ADDENDUM NO. 2

FINANCIAL PROJECT NUMBER: 4821315201

CONTRACT NUMBER: E5W27

DESCRIPTION: I-75 ITS

Florida Turnpike and FDOT Splice

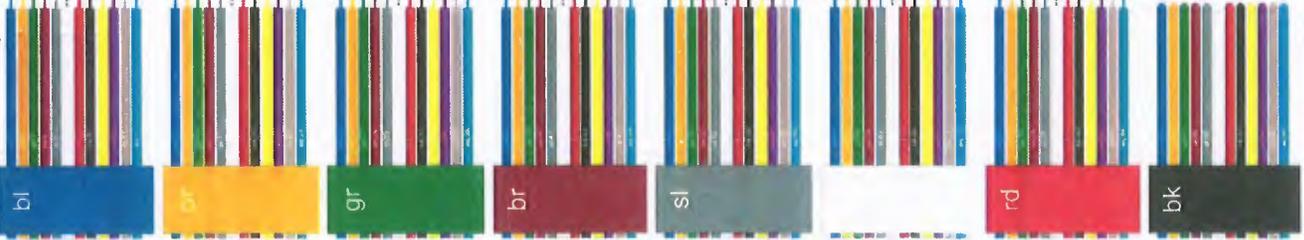
Page 38- Removed the generic termination method and inserted the exist termination at the MH. Left an example of a local hub Patch Panel as well for more detail.
